Field Order #45

Pro	ject: A NEW	A NEW North Whitfield Middle School		18-014/0050CA
	North Whitfield Midd			October 15, 2020
	3450 Cleveland HWY		To:	Womack Lewis & Smith
	Dalton, Ga. 30721		Submitted By:	Josh Scott (KRH)
	Price for Approval Only		Proceed Based on Time and Material Basis	
$\overline{\checkmark}$	Proceed		Clarification	
The Architects Office shall be notified in writing of any field orders that result in adjustments in the contract price or the

Band Room - Technology

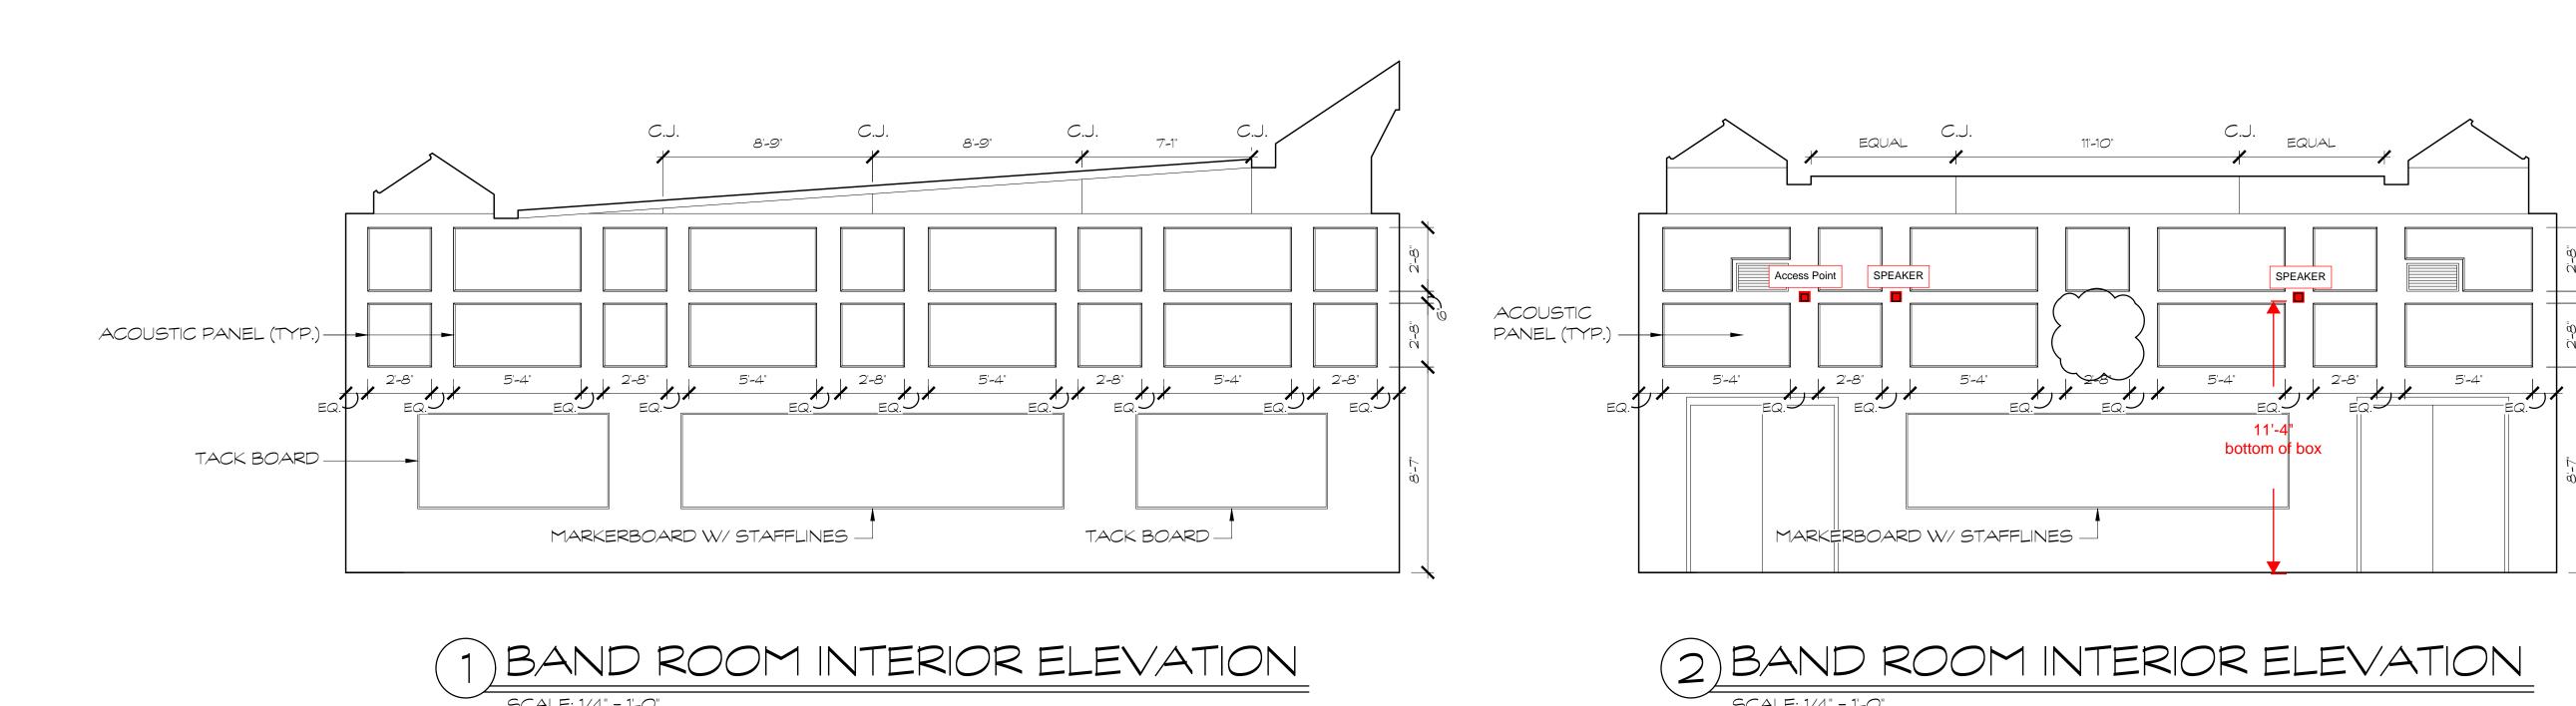
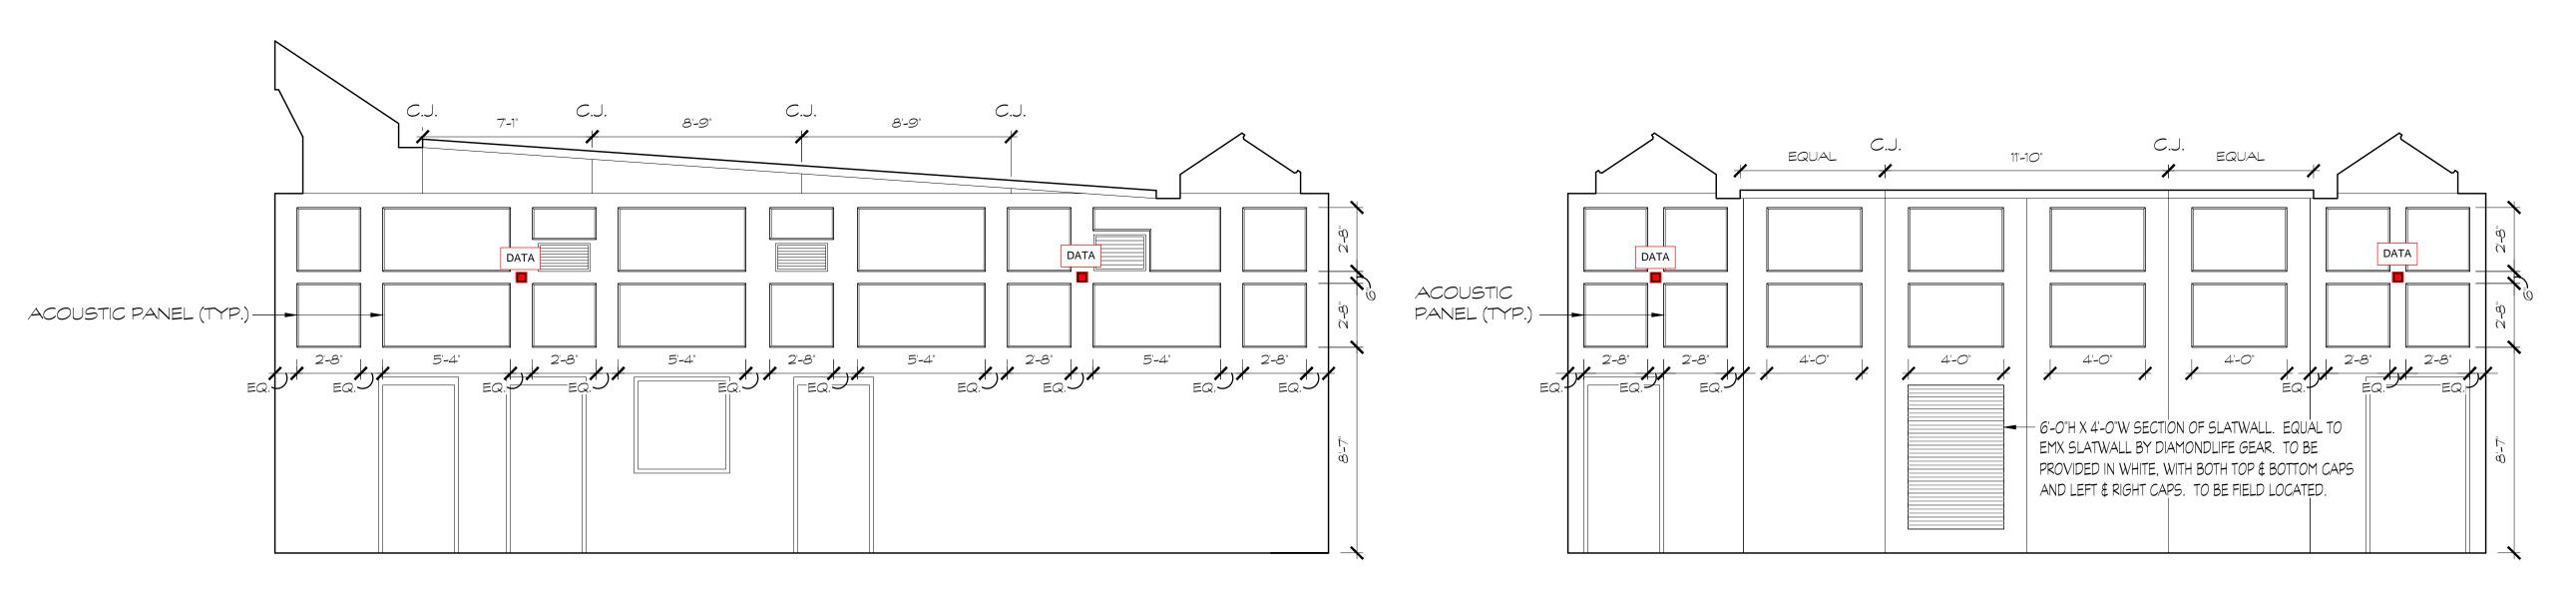
Please add the following as shown below and in the attachment. All data junction boxes to be 2"x2". This will relate to Addendum No. 1, Item #15.

In Band Room 1207, add the following:

Furnish and install a recessed junction boxes on the wall for the owner furnished wireless access points and speakers. Run a 1"conduit with pull rope from the box to the corridor cable tray. Coordinate the exact location and mounting height and box size with the Owner prior to rough-in. Contractor shall include in base bid a quantity of (6) six locations for these boxes and conduits.
